Graphic Textiles Ltd.

Sreeampur, Kalampur, Dhamrai, Dhaka
(23.919114N 90.124967E)

17th May 2014

Observations

Column capacity to be reviewed

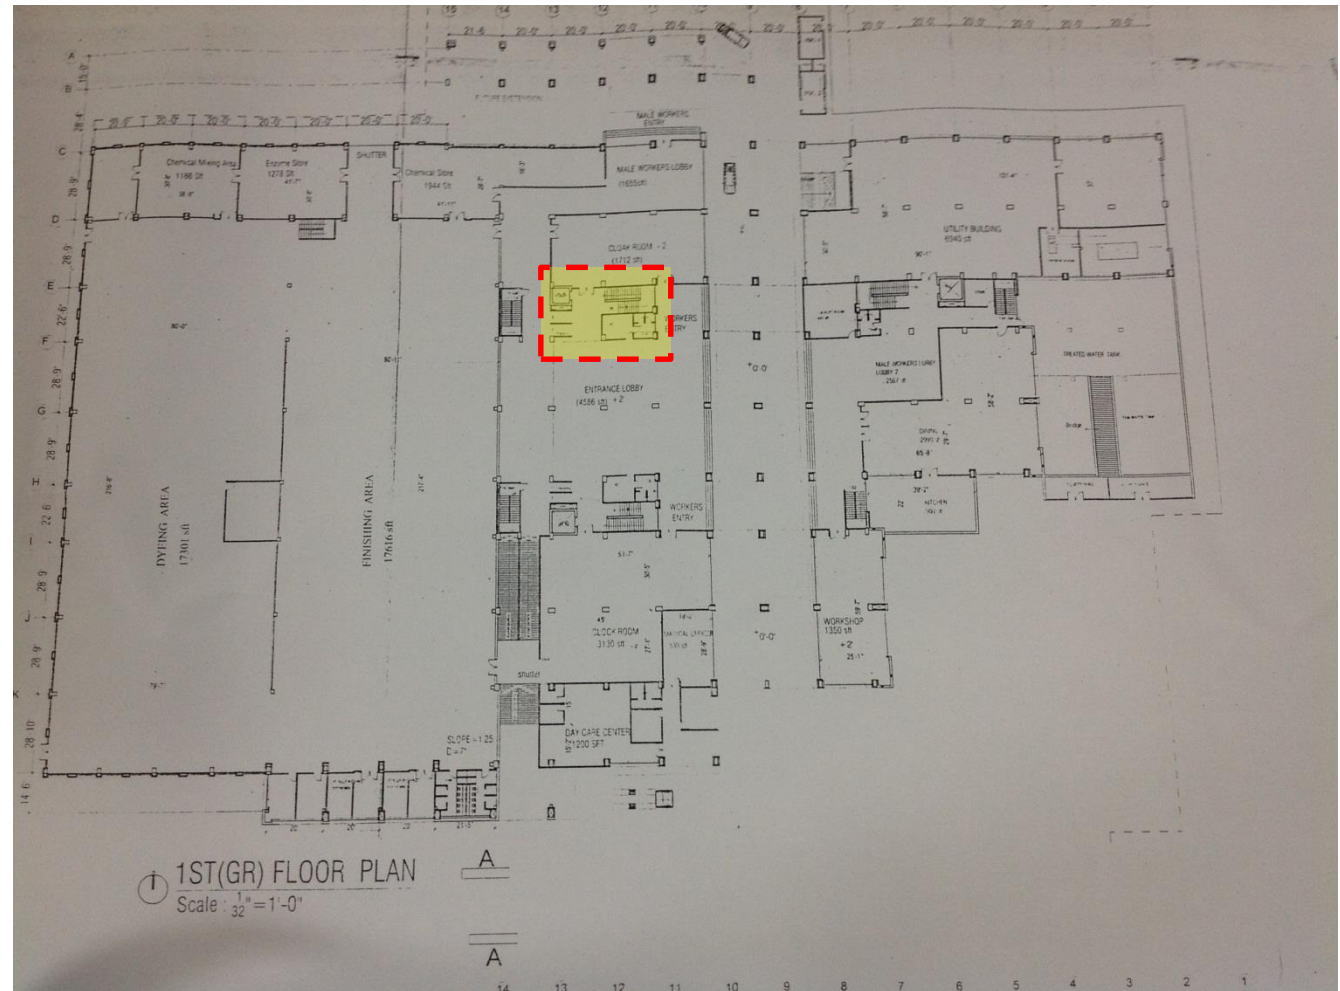
Column capacity to be reviewed

Preliminary calculations indicate that columns at Basement and Ground Floor are stressed to levels that require review. A suitably qualified engineer should confirm that all columns have sufficient capacity to support the applied loads. Columns in the area shaded (where the water tanks and toilets are located) are particularly highly stressed.

We understand that ultrasonic pulse velocity testing has been carried out in the past but that this has not been correlated with results from crushing concrete cores. Without correlation this gives an understanding of the degree of compaction but conclusions about the compressive strength of the concrete cannot be accurately drawn. We therefore suggest that cores be taken from a number of columns to determine the in-situ concrete strength as described in the priority actions later in this report

Item No.	Observation	Recommended Action Plan	Recommended Timeline
1	Review capacity of all columns at Basement and Ground Floor Levels. Note – core tests are required. It is understood that existing pulse wave velocity test results have not been correlated against core tests to determine in-situ strength	Verify insitu concrete stresses either by taking 100mm diameter cores from 4 columns (minimum)or using existing cylinder strength data if available. Vertical reinforcement should be exposed prior to coring to ensure it is not damaged by the coring. Suitably qualified structural engineer to confirm suitable positions for cores to be taken.	6-weeks
2	Review capacity of all columns at Basement and Ground Floor Levels. Note – core tests are required. It is understood that existing pulse wave velocity test results have not been correlated against core tests to determine in-situ strength	Suitably qualified structural engineer to review design, loads and columns stresses in locations specified.	6-weeks

3	Review capacity of all columns at Basement and Ground Floor Levels. Note – core tests are required. It is understood that existing pulse wave velocity test results have not been correlated against core tests to determine in-situ strength	Produce and actively manage a loading plan for all floor plates within the factory giving consideration to floor capacity and column capacity.	6-months

Non engineered lightweight steel roofs

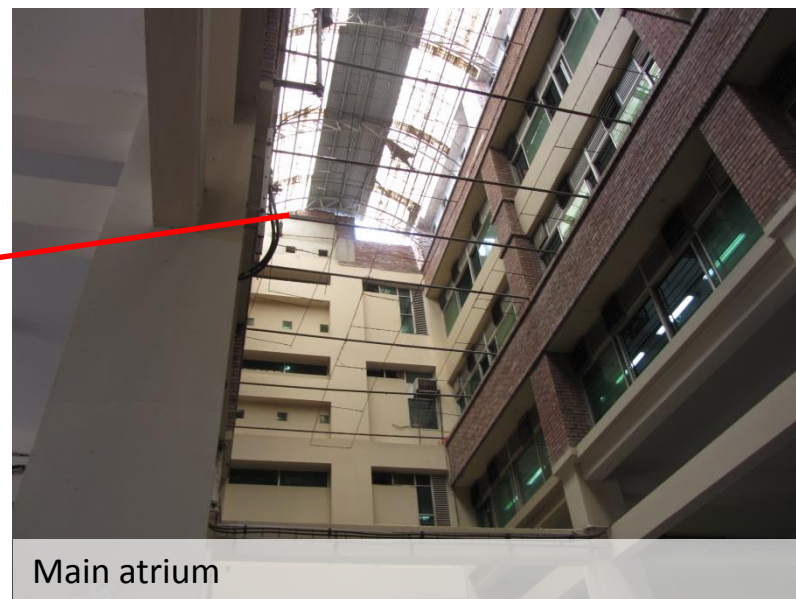
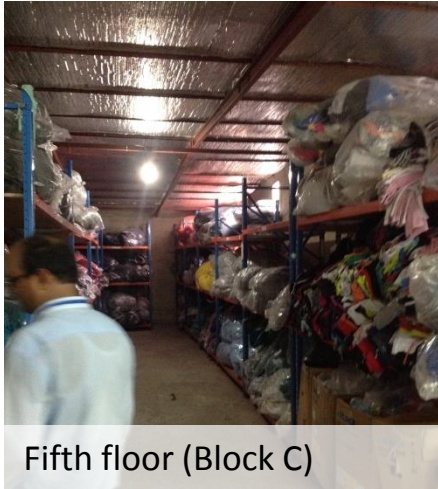
There are a number of non-engineered lightweight steel roofs namely over the fifth floor of Block C, the main atrium between the blocks and the ancillary buildings at the rear of the building.

Item No.	Observation	Recommended Action Plan	Recommended Timeline
4	Non-engineered lightweight roofs	Qualified structural engineer to check the design of both the elements and the connections in lightweight steel roofs for the design loads stated in BNBC-2006. This applies to the roof over the main atrium spaces, the roof over the over the fifth floor and the auxiliary buildings at the rear of the complex.	6-weeks
5	Non-engineered lightweight roofs	Strengthening works to be designed as required.	6-weeks
6	Crack in load bearing masonry wall of ancillary building, possibly due to foundation settlement.	Ensure no materials are being stored against cracked wall.	6-weeks
7	Crack in load bearing masonry wall of ancillary building, possibly due to foundation settlement.	Monitor crack to ensure that no further movements take place.	6-weeks
8	Crack in load bearing masonry wall of ancillary building, possibly due to foundation settlement.	If crack continues to grow, seek advice from a suitably qualified structural engineer.	6-months

Crack in load bearing wall

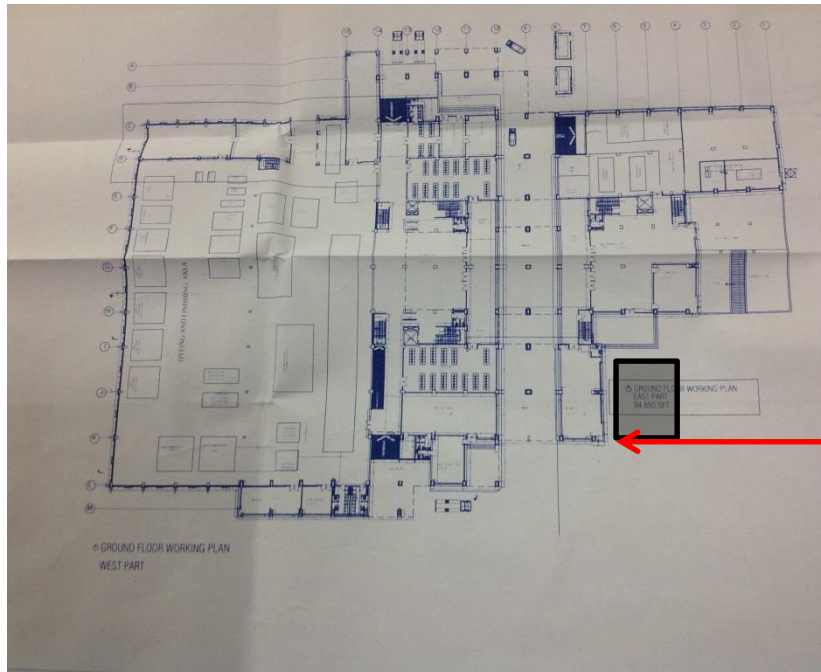
There is a crack in a load bearing wall on one of the auxiliary buildings (not shown on layout drawings). This may be caused by foundation settlement. The crack width should be monitored and, if it increases in size, advice should be sought from a qualified Structural Engineer. No materials should be stored against the wall.

9	Crack in load bearing masonry wall of ancillary building, possibly due to foundation settlement.	Continue to monitor crack and repair as necessary to avoid on-going maintenance issues.	6-months

Inconsistencies in record information

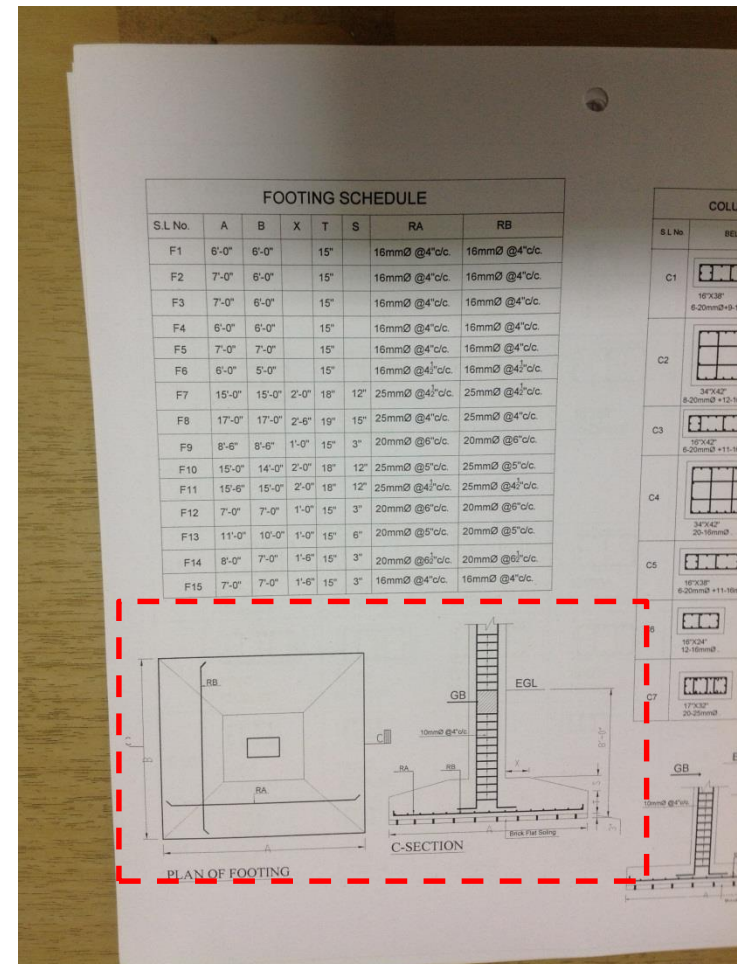
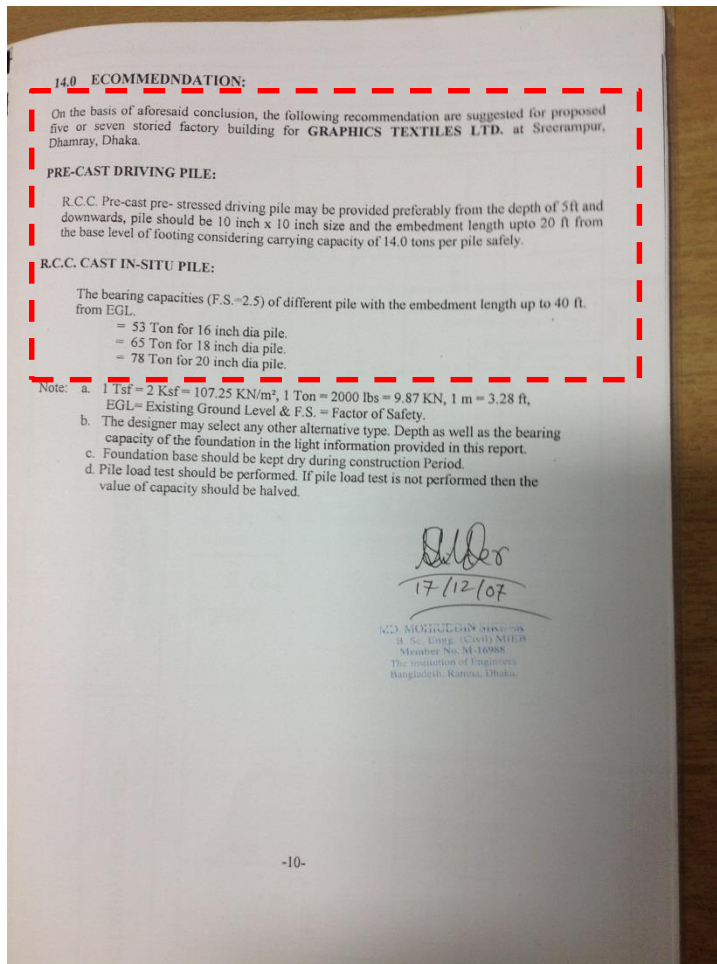
The soils report suggests piled foundation while the record drawing show pad foundation. A suitably qualified structural engineer should confirm the foundation type and that the foundations have sufficient capacity for the applied loads.

Item No.	Observation	Recommended Action Plan	Recommended Timeline
10	Inconsistencies in record information/differences between drawings and as-built structure	A suitably qualified Structural Engineer should confirm the foundation type and that the foundations have sufficient capacity for the applied loads	6-months
11	Inconsistencies in record information/differences between drawings and as-built structure	As built drawings should be updated to reflect exact construction dimensions	6-months
12	Columns constructed above sixth floor on Block B	Construction above roof on Block B should be removed.	6-months

Differences between drawings and structure

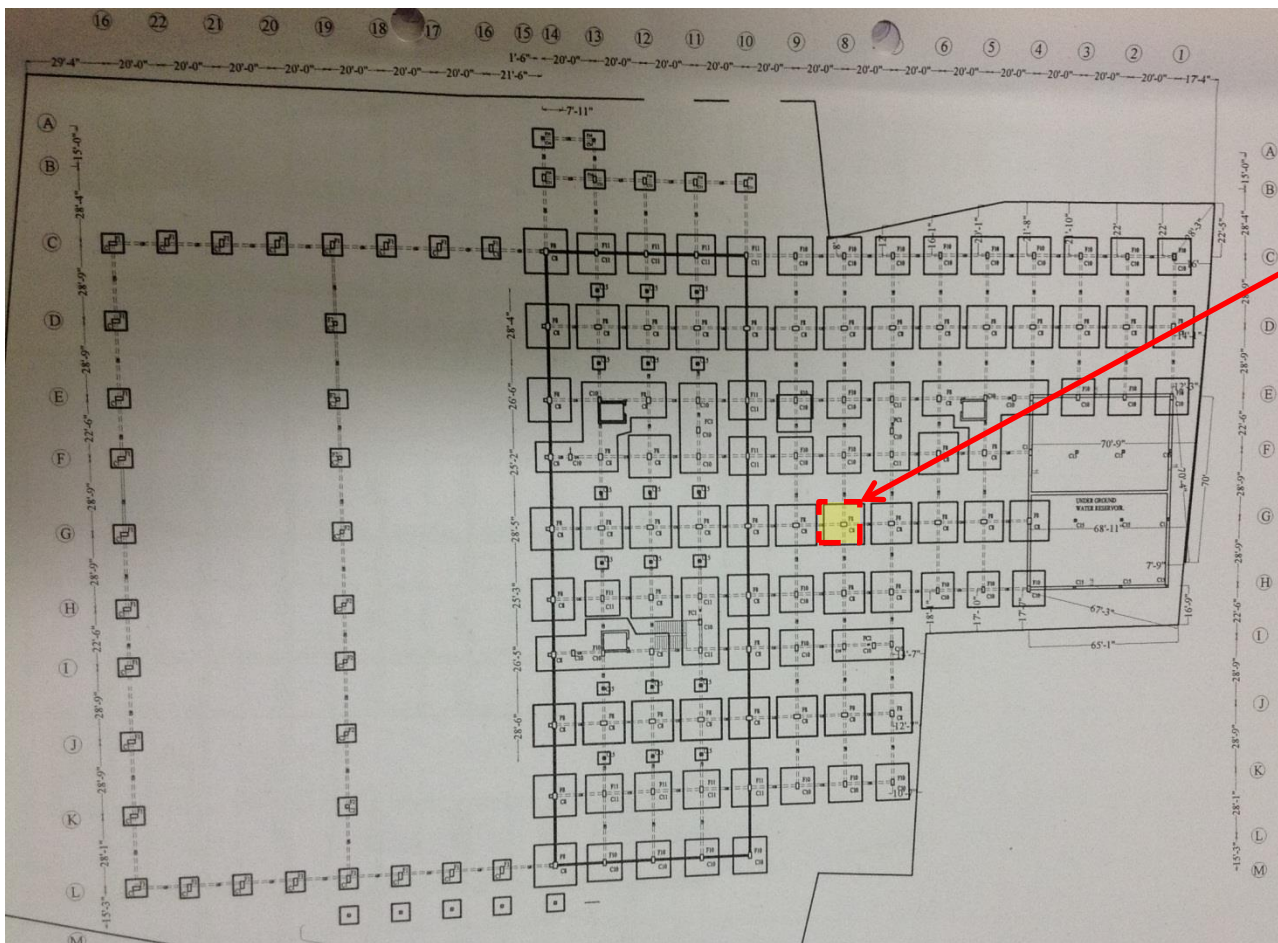
The column shown here is a 'C8' on the column schedule (610mm x 760mm) at ground floor. This was measured as 800mm x 870mm (RC section size) on site.
